# UNITED STATES PATENT AND TRADEMARK OFFICE

10/576,099

| <b>Office Action Summary</b> | <b>Application No.</b><br>10/576,099 | <b>Applicant(s)</b><br>EVANS ET AL. |  |

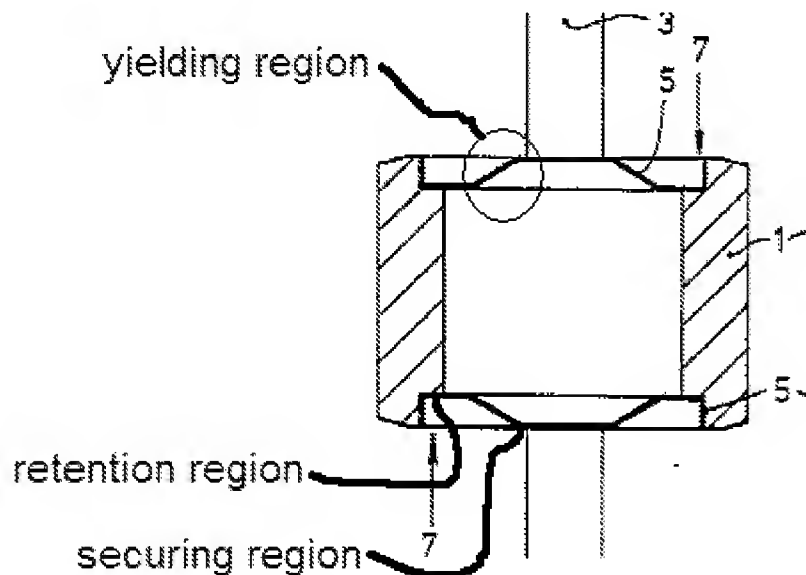
For claim 25, Weiland teaches each said at least one covering disk comprising a yielding region (see figure 1, and figure below).

For claim 26, the yielding region as explained for claim 25 above can constitute a bead extending in the circumferential direction.

For claims 30 and 31, the yielding region as disclosed by Weiland can be considered to be embodied as a connecting region, disposed between a securing region

and a retention region for the magnet element, and wherein the connecting region is inclined to the securing region (see figure above).
